DA/2024/1362 RESPONSE TO RFI REPORT

Farmhouse Restaurant
40 Myoora Road, Terrey Hills

Prepared for
ISAAC PROPERTY
9 April 2025

Figure 1 Comparison of north-west section plan

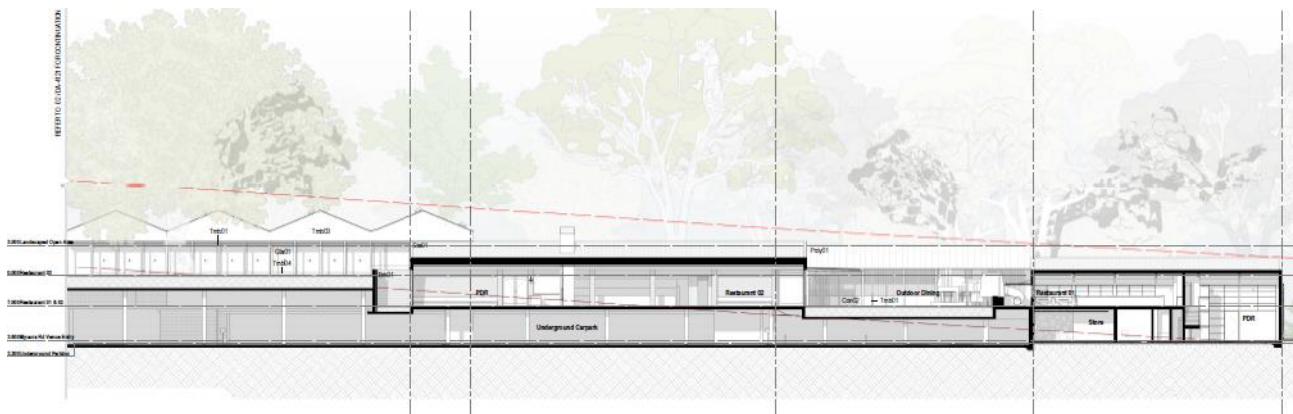
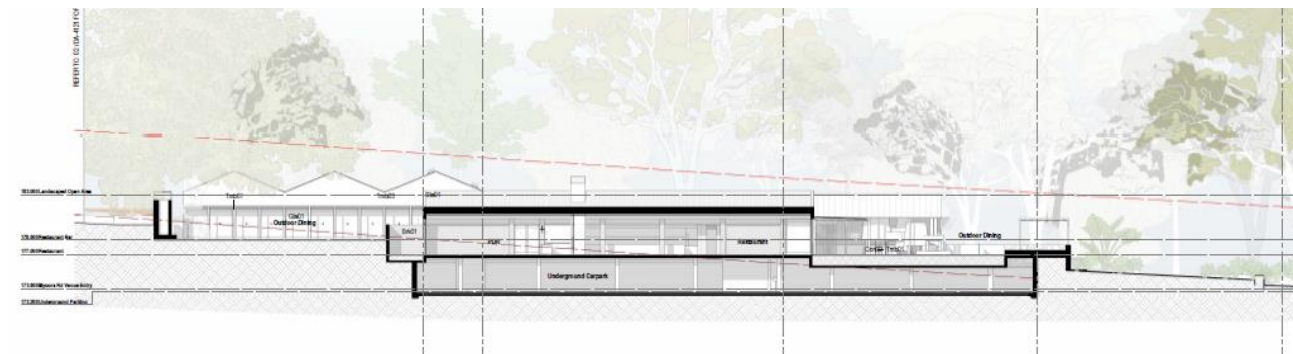
The key built form changes are the removal of the restaurant 1 pavilion building, consolidation of the two restaurants and BOH in the main building, and reduction in the area of the basement so that the car park does not extend under restaurant 3. This will result in less excavation on site, an overall reduction in site coverage and a reduction in the bulk and scale of the built form on the site.

This is illustrated in the comparison of north-west section plan in **Figure 1**.

Figure 2 Comparison of site plan

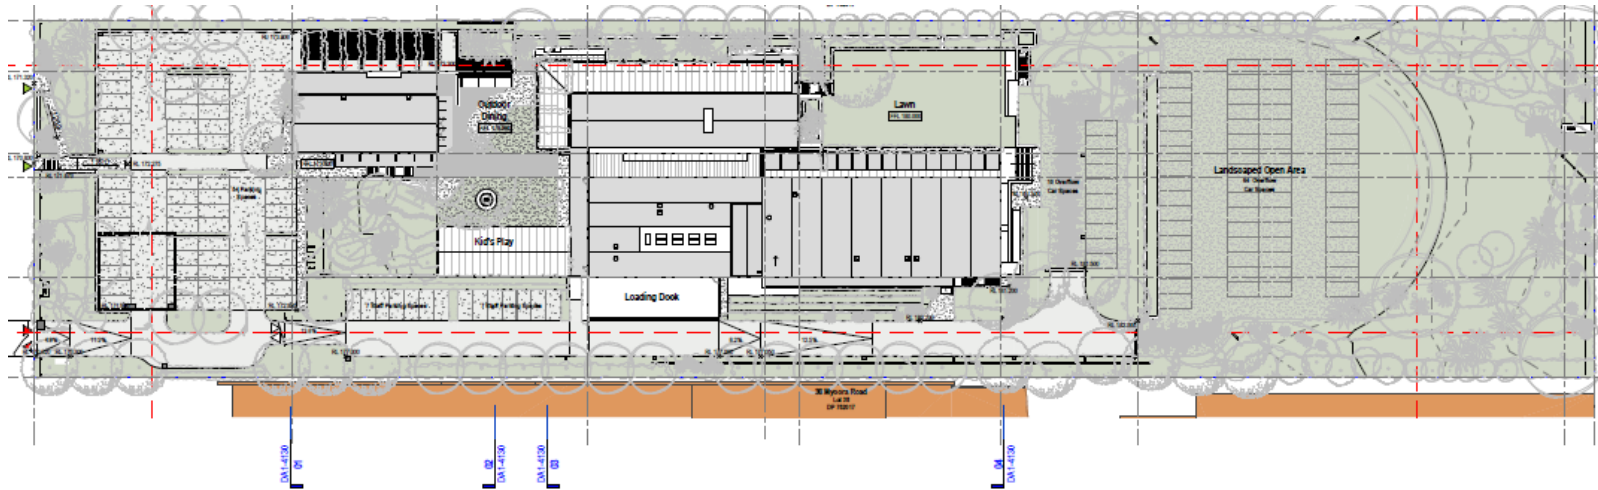
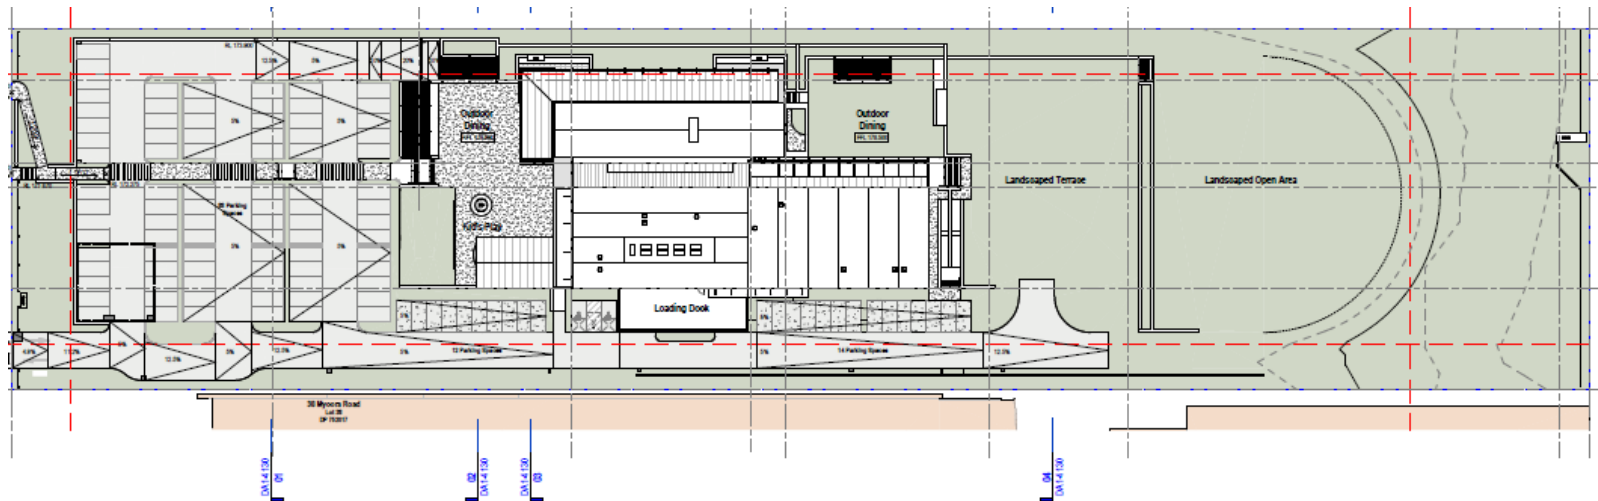
Furthermore, the amended scheme does not seek consent for any overflow car parking on the Mona Vale landscaped frontage. This area will comprise only landscaping with a retaining wall and stair access. The removal of the overflow parking will ensure this area functions as genuine landscaped area with no vehicular impact on the quality of vegetation.

A comparison of the lodged and proposed site plan is provided in **Figure 2**.

Figure 3 Comparison of seating plan

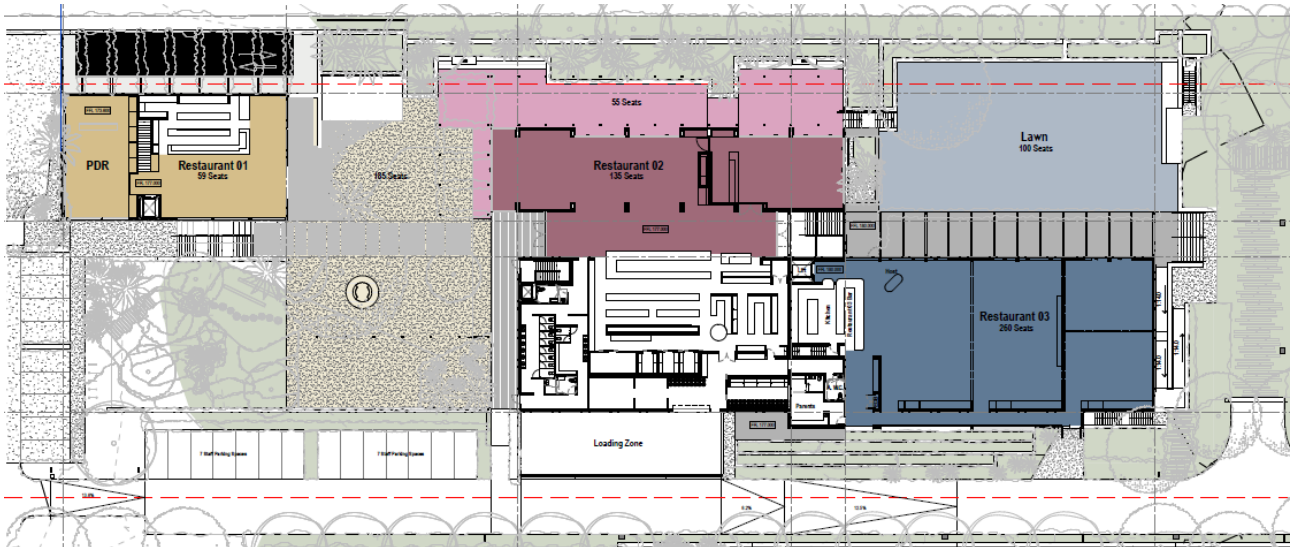
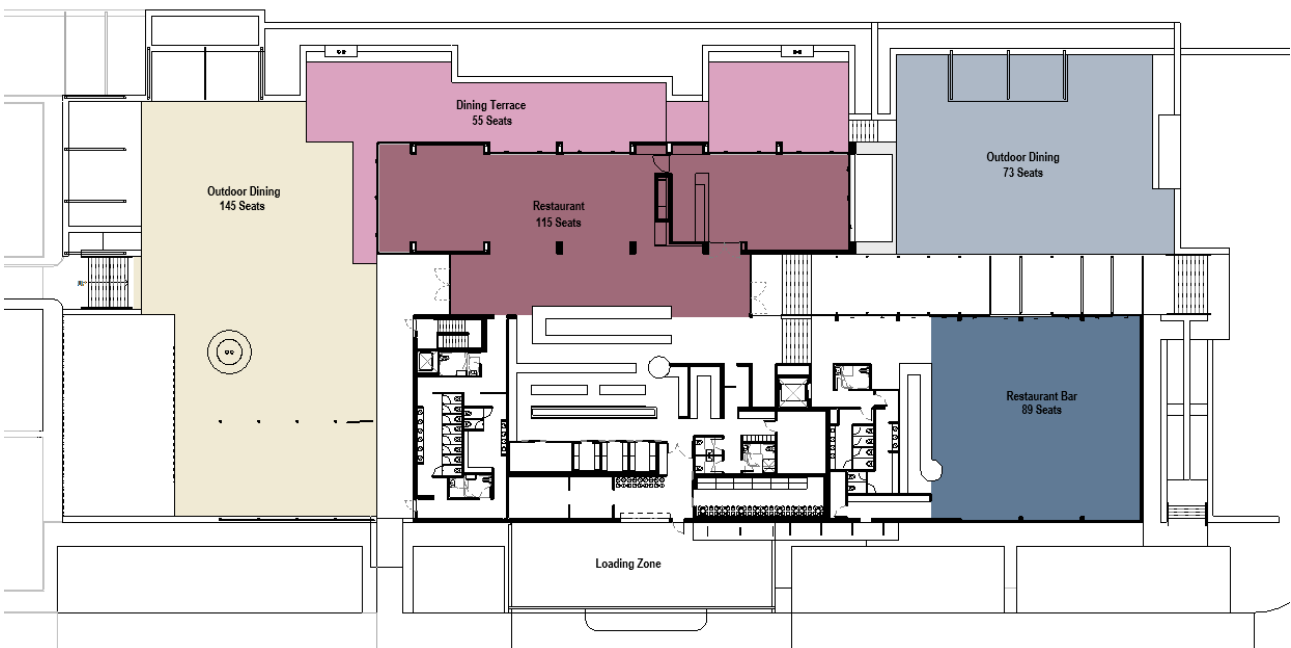
The changes consolidate the restaurant offerings into a single offering and removes restaurant 1 from the proposal. Overall, this will result in a reduction in patron capacity by 200, from 794 to 594, which represents a refined and manageable offering for this site. The reduction in patron capacity and operation is clearly represented in the following comparison of the seating plan for the lodged and amended scheme.

Figure 4 Comparison of landscape plan (Myoora Road interface)

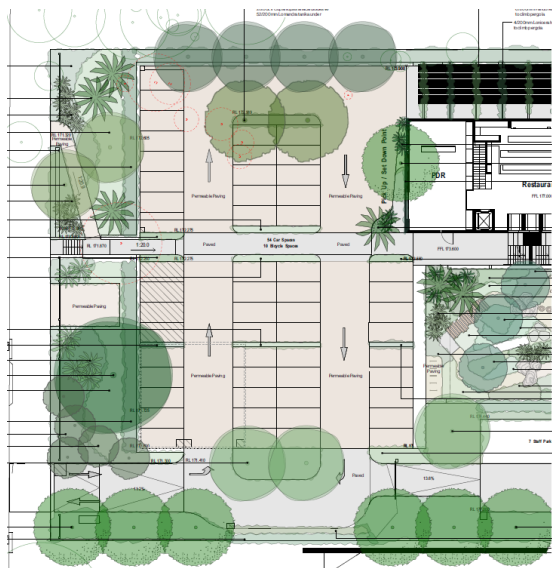
Increase in landscaping across the site from 8,194 plants (93% native) to 11,642 plants (99% native) across 9,314sqm of landscaped area. Changes include:

- Addition of tree canopy planting in the car park area adjacent to Myoora Road. This will improve screening of the built form when viewed from the public domain.
- Increased planting from 8,194 plants (93% native) to 11,642 plants (99% native) across 9,314sqm of landscaped area.
- Removal of an area of permeable paving in the Myoora Road setback on landscape drawing LP02-D0224 and replacement with mass planting.
- Amendment to planting species so the Threatened Ecological Community Duffy's Forest species to form the majority of planting species (55%). The use of locally indigenous groundcovers and grasses such as *Hibbertia bracteata* and *Lomandra longifolia*, as well as canopy trees such as *Eucalyptus haemastoma* and *Angophora costata*, have been selected to help the regeneration of this endemic community.

A comparison of the lodged and proposed Landscape Plan is provided below.

Figure 5 Comparison of landscape plan (Mona Vale Road interface)

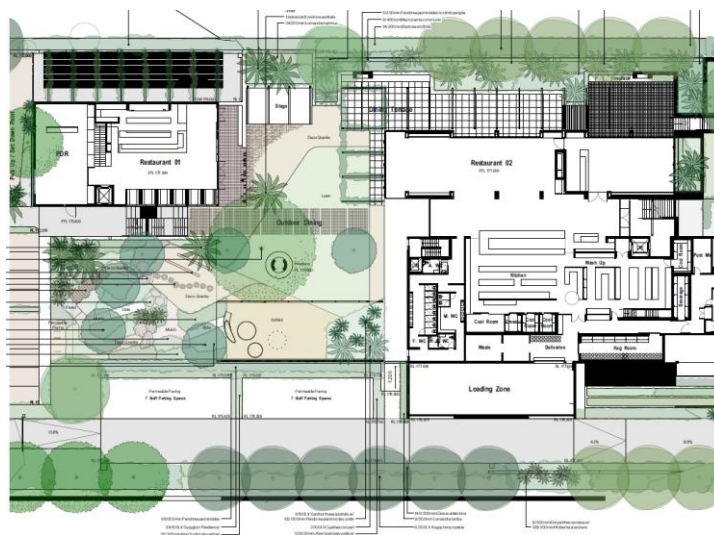
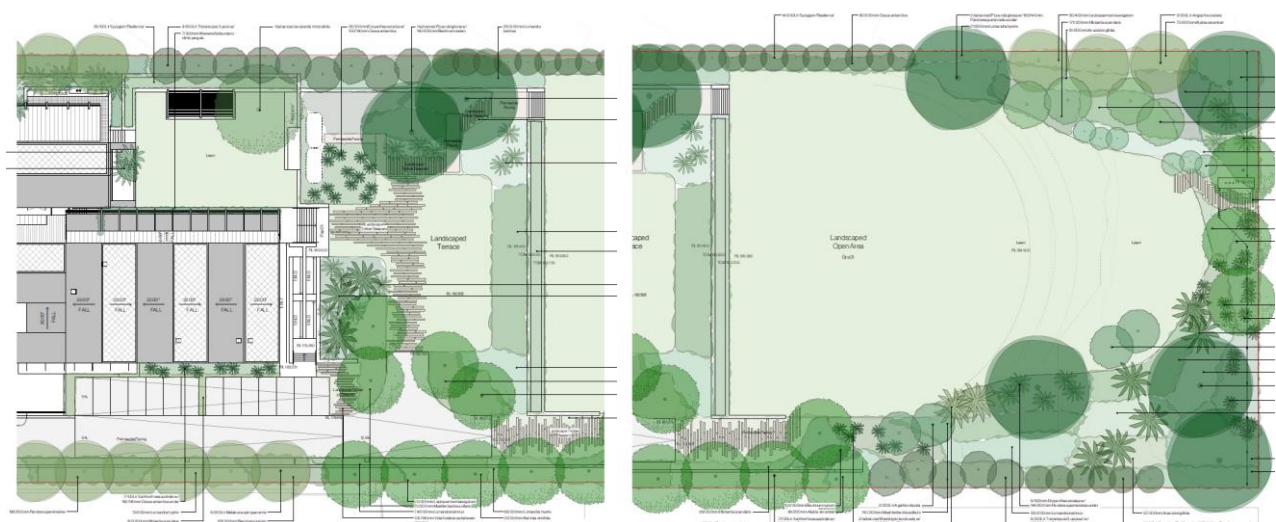
Picture 10 Amended as proposed illustrating removal of overflow car parking and increased landscaping
